RAI Volume 2, Chapter 2.1.1.1, Second Set, Number 3:

On August 4, 2009, the DOE participated in a clarification call with the NRC regarding RAI 2.2.1.1.1-2-003. Three areas requiring clarification were identified as follows:

Response Tracking Number: 00072-01-00

RAI: 2.2.1.1.1-2-003

Figure 1. Schematic Diagram Showing Geometric Distance from the Edge of the Fault Damage Zone (Taken as a Plane) to Closest Point on Waste Package

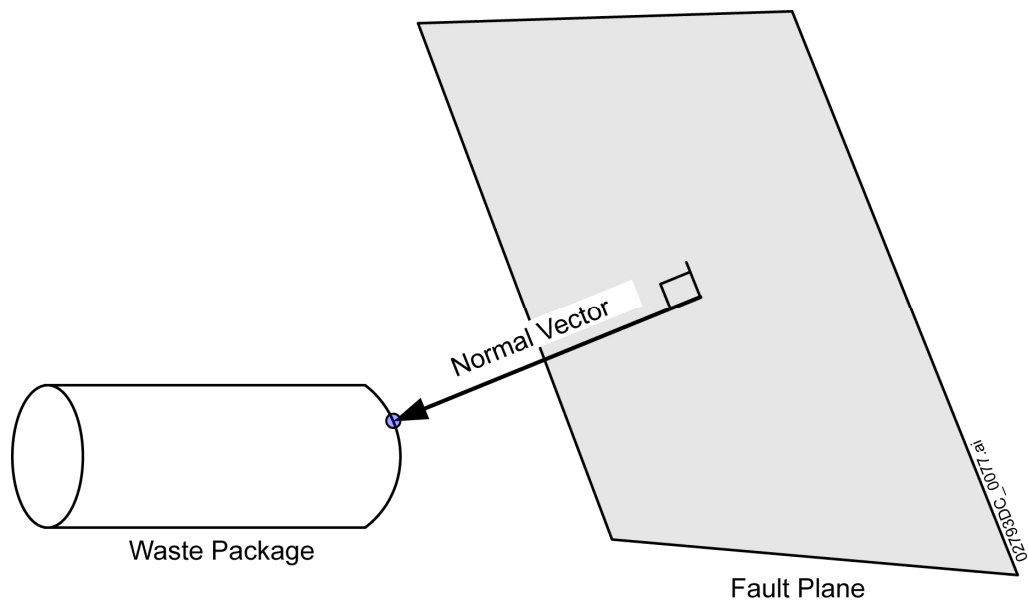
- e. **RAI Volume 2, Chapter 2.1.1.1, Second Set, Number 3, Figures on Page 13 of 13:** Clarify how the standoff distances from fault and fault zones to the edges of an emplacement drift or to ITS and ITWI surface facilities are calculated to ensure that the shortest standoff distance is calculated in the context of the three-dimensional setting and not just in a simplified two-dimensional setting.

To address the preclosure safety requirement of PSC-25 for faults in the subsurface, the standoff is measured as the shortest geometric distance from the fault damage zone (defined in Section 1.2.1 of this response) or its projection to a point on any adjacent waste package. Figure 2 of the original response depicts the standoff distance in an emplacement drift for a simple case and was intended for illustrative purposes only and not to provide a definitive methodology for measurement. The figure was also not meant to suggest a simple two-dimensional measurement along the tunnel axis.

To ensure that the shortest standoff distance is calculated in this case, the measurement of the standoff distance can be accomplished in three-dimensional space using plane geometry by representing the edge of the fault damage zone as a plane (e.g., measured in terms of strike and dip from the surface in the emplacement drift), as illustrated in Figure 1. Computing the normal to the plane using a three-dimensional coordinate system and identifying the closest point on the waste package planned for emplacement near the fault, the minimum distance can be computed between a fault plane defined as $ax + by + cz + d = 0$ and a point $p = (x_1, y_1, z_1)$ using the following equation:

where D is the minimum distance between an identified point on the waste package and the fault. To compute the absolute shortest distance (i.e., the global minimum) as a basis for the standoff distance, it may be necessary to examine several points on the waste package. This computation process can be automated in a simple computer code or calculated by hand for several points on the waste package until the global minimum is identified as a basis for the subject standoff criterion. The actual process will be described in future operational procedures.

Figure 2. Schematic Diagram Showing Variables for ITS Surface Structure Standoff Distance Using 1:1 Approach

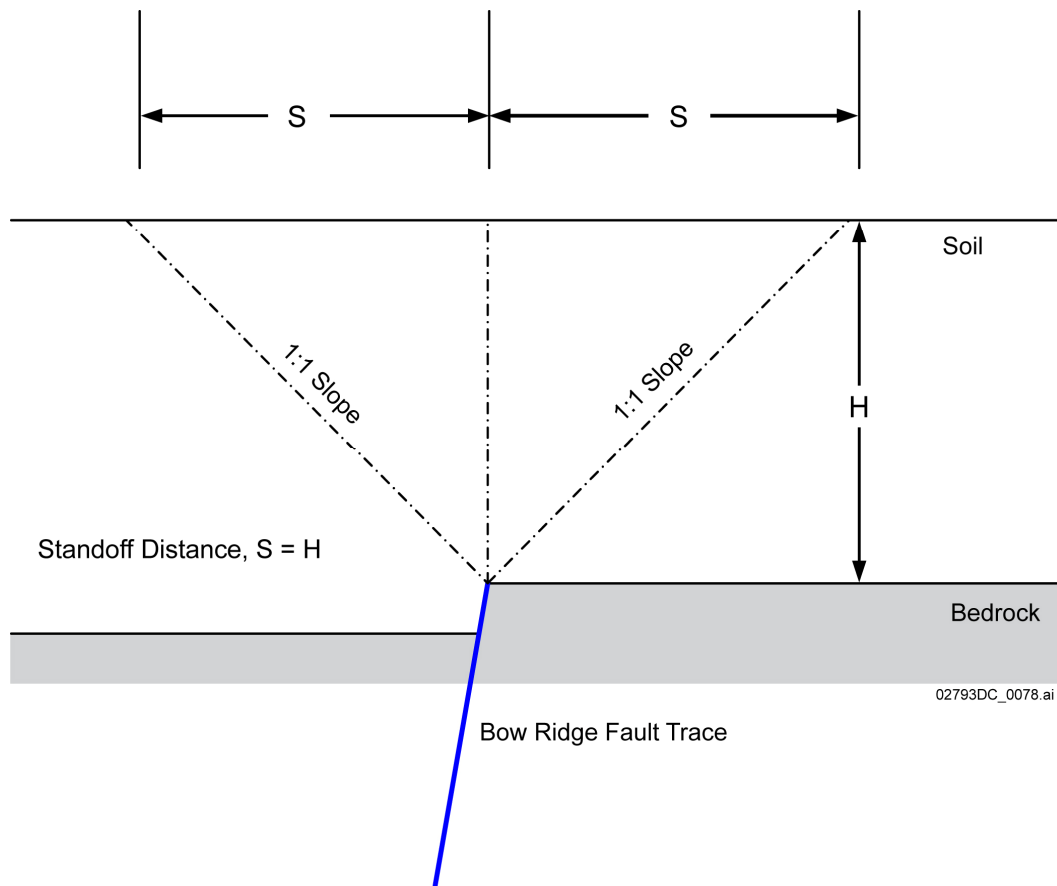
- c. **RAI Volume 2, Chapter 2.1.1.1, Second Set, Number 3, Section 1.4.1, Page 9 of 13:** Clarify the criteria and their technical bases to select a standoff distance to significant displacement (e.g., Bow Ridge Fault or other faults at the surface GROA). As an example, clarify the technical bases to relocate aging pads 17P and 17R to about 300 feet east of the reinterpreted location of the Bow Ridge fault (Orrell 2007).

A standoff distance for the aging pads from the Bow Ridge Fault is established based on the characteristics of this fault and employs a straightforward rule to define a standoff that allows for some variation in the location of the fault and of the rupture zone at the surface. The aging pads are presently located over 100 m from the fault trace to ensure that the standoff distance is met with sufficient margin. In more detail, the standoff criterion for the ITS aging pads is implemented by defining a 1:1 slope from the location of the fault trace at the bedrock surface projected upward through the local soils to the surface, as shown in Figure 2. The standoff is defined for a normal fault, with the understanding that the fault rupture through the soil will initially trend along the orientation of the expected fault surface and then will curve toward the vertical after some distance. This behavior and uncertainty in location of the fault is reasonably captured by the 1:1 slope defining the standoff. For this criterion, the horizontal standoff distance

from either side of the bedrock fault trace is equal to the depth of soil at the location of concern. From an examination of borings in proximity to the fault in the aging pad area, the maximum depth of soil is about 49 m (162 ft) (Table 1). Use of this maximum soil depth with the 1:1 standoff approach results in a 49 m standoff distance from the Bow Ridge Fault bedrock trace at the aging pad location.

Figure 5. Revised Illustration of the 60 Meter Fault Standoff Distance of a Waste Package from a Quaternary Fault with Potential for Significant Displacement

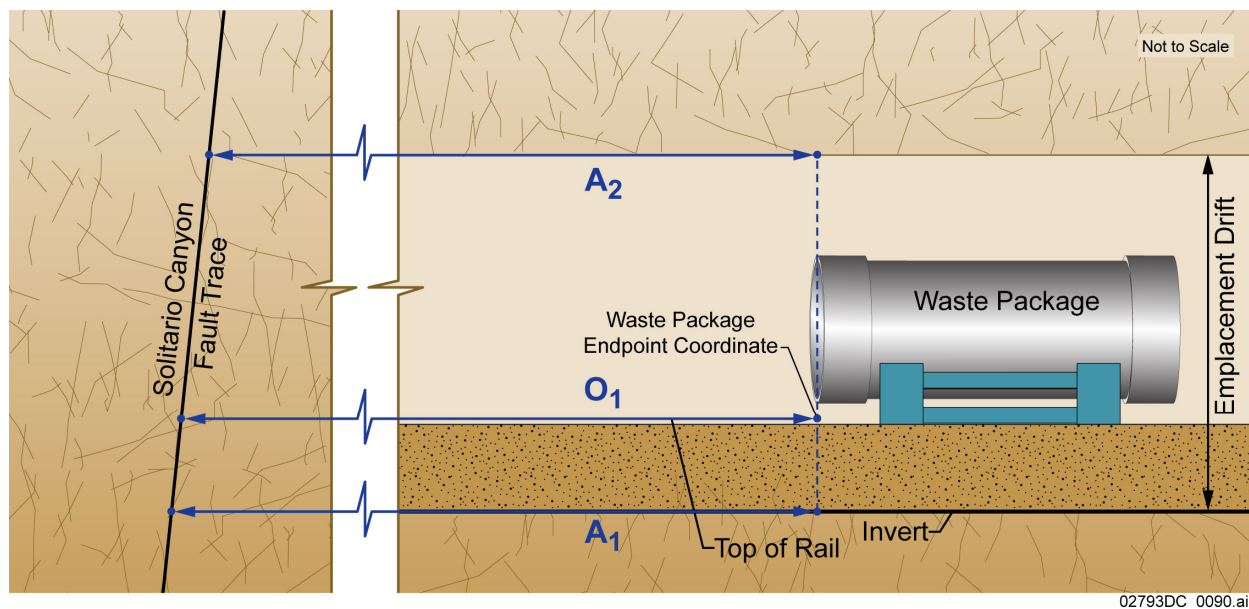
- a. **RAI Volume 2, Chapter 2.1.1.1, Second Set, Number 3, Section 1.4.1, Page 9 of 13:** Clarify the criteria and technical bases to select a 60 m standoff distance from an emplacement drift waste package end point coordinate (WPEC) to a Quaternary fault of significant displacement such as the Solitario Canyon Fault.

In implementing design control parameter 01-05, the closest approach of the trace of a Quaternary fault with potential for significant displacement to any underground opening in the subsurface GROA (including access mains) exceeds 60 m (197 ft) based on the layout design (BSC 2003, Section 7.1.3). As the waste emplacement is typically located an additional 60 m (197 ft) to the interior away from the access mains, as measured perpendicular to the access main (and away from the Solitario Canyon and Bow Ridge Faults) (e.g., see SAR Figure 1.3.3-34), the design provides a total minimum separation of at least 120 m (395 ft) from a waste package endpoint coordinate (WPEC) to the Solitario Canyon Fault trace.

The 60 m standoff distance of emplacement drifts from a Quaternary fault with potential for significant displacement, in accordance with design control parameter 01-05, is measured in a horizontal plane at the emplacement level. For this distance measurement, the edge of any emplaced waste package (i.e., the WPEC) is delineated as the edge of the emplacement area. As a clarification to the original RAI response, the 60 m (197 ft) fault standoff distance is measured in the original layout calculation as the shortest distance from the emplacement drift’s WPEC (located horizontally at the top of rail) to the main fault trace projected to the elevation of the emplacement drift (line O₁ in Figure 5). A more comprehensive method for this measurement has been recently identified and used to confirm the standoff distance (as described in the original response to RAI 2.2.1.1.1-2-003), which involves taking two such distance measurements: one at the plane of the emplacement drift invert (base of excavation) elevation and a second measurement at the plane of the emplacement drift crown, with the shorter of the two distances used for compliance confirmation (i.e., the shorter of the two lines A₁ and A₂ in Figure 5). A revised figure showing both these methods is attached (Figure 5). As the orientation of both the Solitario Canyon and the Bow Ridge Faults (i.e., the strike) is approximately parallel to the edge of the subsurface GROA, the latter method accounts for fault dip and thereby provides a minimum distance with sufficient accuracy for the postclosure requirement and is planned to be used for operations. Further, significant margin exists for the standoff requirement for the closest approach of this type of fault to the emplacement area. The Solitario Canyon Fault, which has the closest approach to Panel 4, as described in Section 1.1, provides a total minimum separation of the waste package endpoint from the Solitario Canyon Fault trace of at least 120 m (395 ft).

NOTE: Figure supersedes Figure 1 of original response to RAI 2.2.1.1.1-2-003.

Figure 6. Idealized Cross-Section of a Tunnel Geology to Illustrate Difference Between a Fault Damage Zone and a Fault Zone of Influence

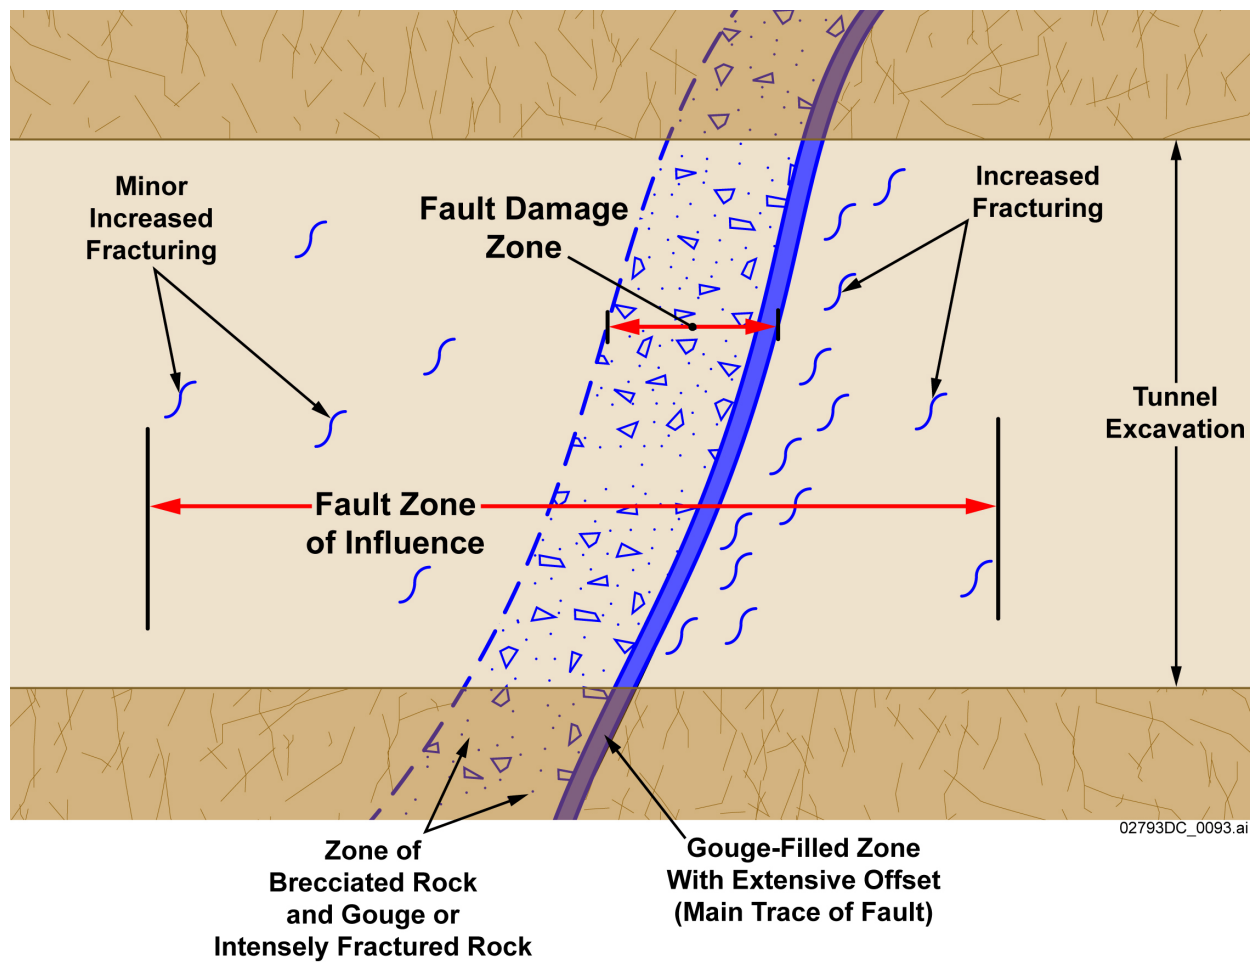
- a. **RAI Volume 2, Chapter 2.1.1.1, Second Set, Number 3, Section 1.2.3, Paragraph 2, Line 5, Page 6 of 13:** Clarify the definition and criteria of a fault damage zone and of a fault zone of influence for the purposes of

standoff and clarify and quantify the criteria of narrow and wide fault damage zones.

For the determination of a standoff distance, a “fault zone of influence” is not identical to a “fault damage zone.” A fault zone of influence is a zone around the principal fault plane in which fracture intensity (defined as the number of fractures per unit of length) is higher than in the surrounding rock or in which some other parameter (such as fracture orientation) changes in response to the presence of the fault, as described in the license application (SAR Section 1.1.5.1.3.2). This is illustrated in Figure 6. As related to preclosure safety methodology, a fault damage zone is a zone adjacent to a fault where the hazard of rockfall or fault rupture (which can potentially breach the waste package) is significantly increased from the hazard identified for the overall rock mass around an emplacement drift (the rockfall hazard is addressed in preclosure safety for typical emplacement drift conditions with a bounding approach in which a large rock block controlled by local jointing is considered).

A “fault zone” is typically used to describe the zone of intense fracturing (i.e., very closely spaced fracturing) with breccia and/or gouge. However, in SAR Section 1.1.5.1.3.2 and elsewhere in the license application, the term “fault zone” is used more broadly, and includes a zone of influence. Therefore, a fault zone in the context of the SAR is larger than the zone of primary fault displacement and associated intense fracturing (as illustrated in Figure 6). Mechanistically, the term “fault zone” as used in the SAR includes parameter changes (such as changes in fracture intensity or orientation) in the rock mass associated with the original formation of the fault, as well as subsequent deformation due to successive fault displacement. It is noted, however, that once a fault exists, subsequent deformation (and the impact on the surrounding rock mass) can be more limited than the original formation disturbance, depending on the characteristics of the fault. Therefore, displacement of an existing fault is expected to be restricted to a much more narrow zone than that defined by the “zone of influence,” which encompasses the total changes to the rock mass due to fault creation and subsequent displacements.

For the purposes of describing the preclosure safety hazard, the term “fault damage zone” is introduced in this response, distinct from a “fault zone of influence” or a “fault zone” (Figure 6). A fault damage zone is defined as a zone of faulting that can represent a potential hazard for breaching a waste package. The extent of a fault damage zone includes zones of intense fracturing with breccia or gouge between the surfaces of the fault as well as zones of intense fracturing (i.e., zones of closely spaced fractures) directly associated with a fault. However, the term does not include zones of rock that are largely intact with some minor additional fractures or minor changes in properties. The definition also does not spatially combine fractures or zones that are widely spaced.
